SUNDRY NOTICES AND REPORTS ON WELLS
Do not use this form for proposals to drill or to re-enter an abandoned well. Use Form 3160-3 (APD) for such proposals.

Apache Corporation

Hawk B-3 #26

☒ Change Plans

BOP SCHEMATIC

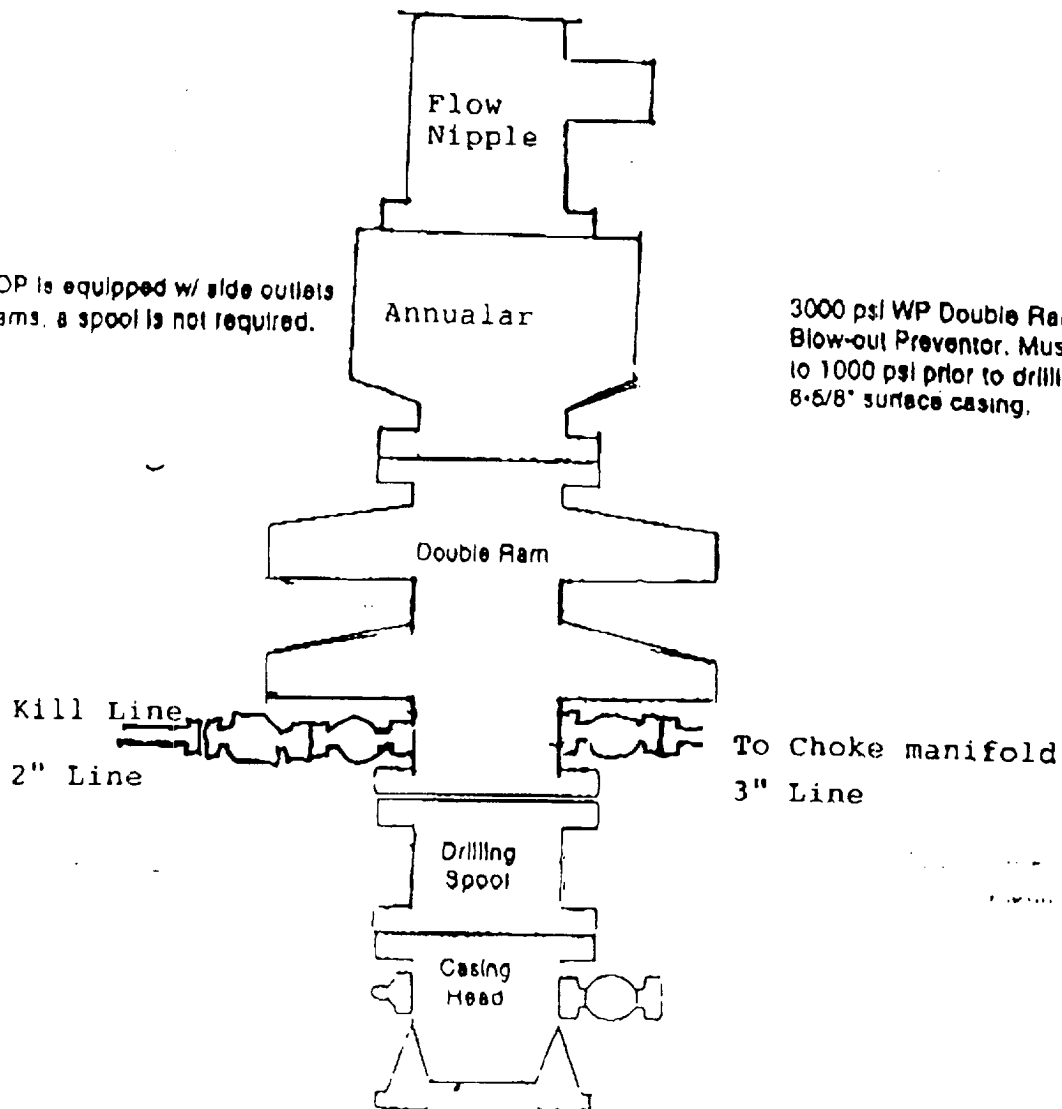
Apache Corporation has drilled and set the surface casing using the above BOP, but wishes to continue drilling the well with a 9" x 3000 psi BOP as shown on the attached schematic, with a like waiver of the remote control requirement for the accumulator.

Minimum working pressure of the blowout preventer and related equipment (BOPE) shall be 2000 psi with a minimum of One Annular Preventer or Two Ram-Type Preventers and a Kelly Cock/Stabbing Valve. The requested variance to test the BOPE to the reduced pressure of 1500 psi, using the rig pumps is approved.
